SECTION 904 - NOTICE TO BIDDERS NO. 4963

SUBJECT: Quantity Corrections

Replacing 5 Bridges on SR 7 from Humphreys County Line to US 82, known as Federal Aid Project No. BR-0061-02(008) / 103327301 in Leflore County.

ADDENDUM

PLAN OF SPANS 7 & 8

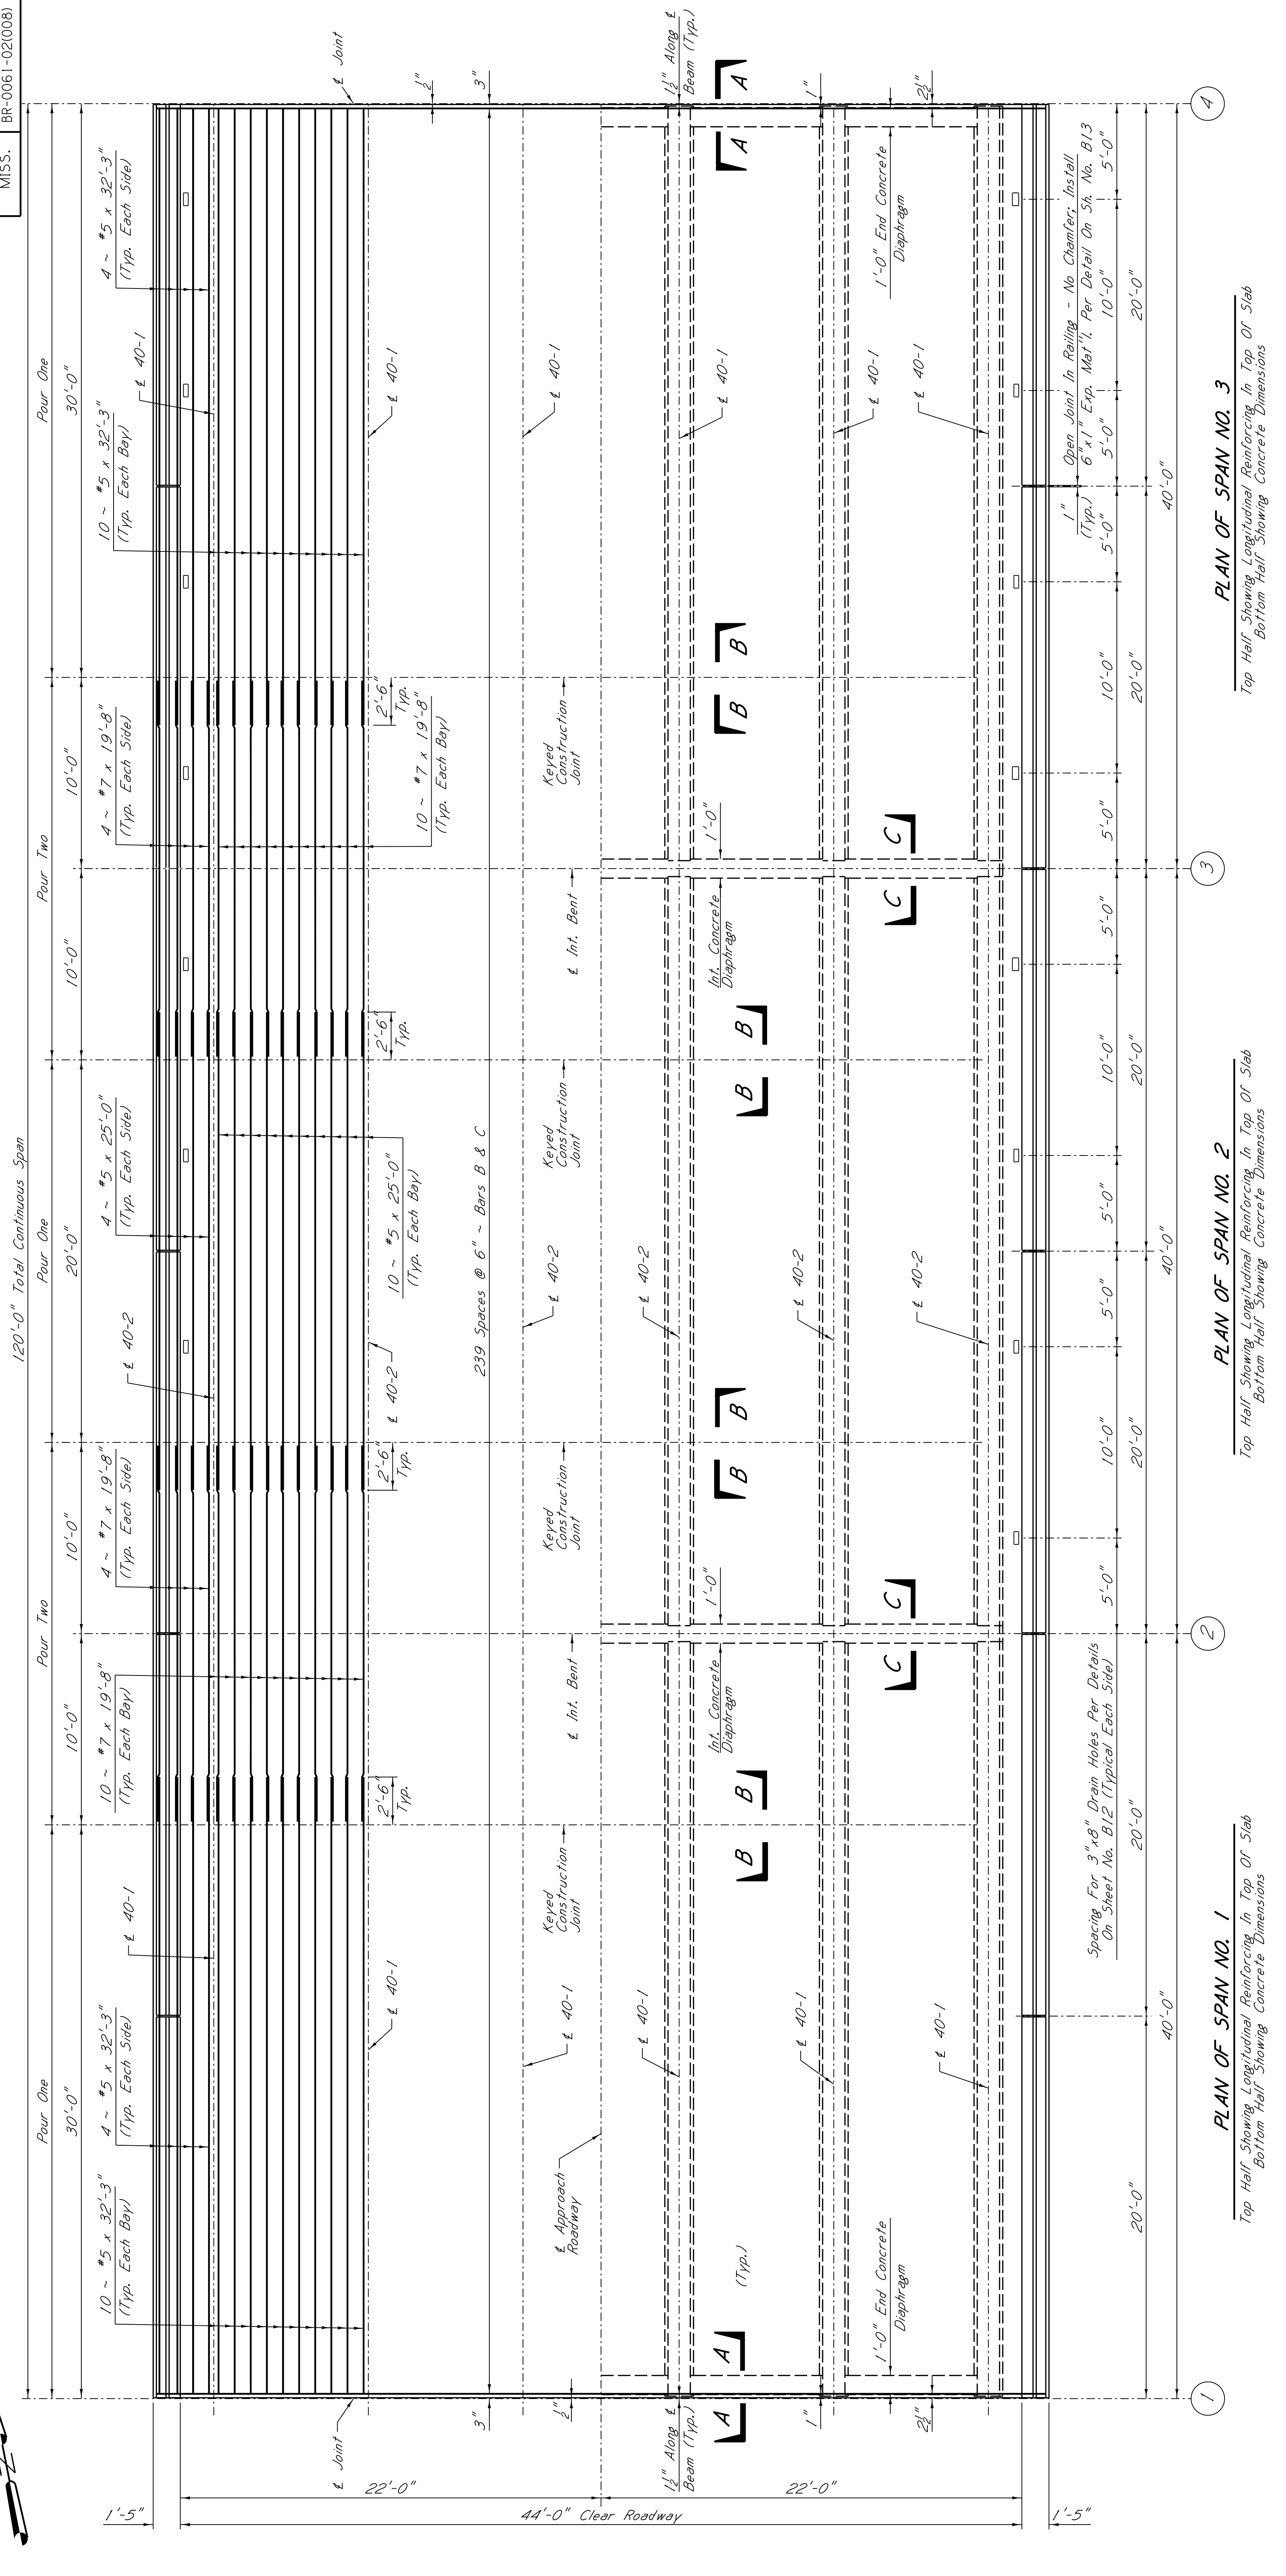
The Deck Pouring Schedule As Shown On These Plans Is Recommended And Shall Be Used Unless An Alternative Pouring Sequence Is Submitted And Approved By The Director Of Structures, State Bridge Engineer.
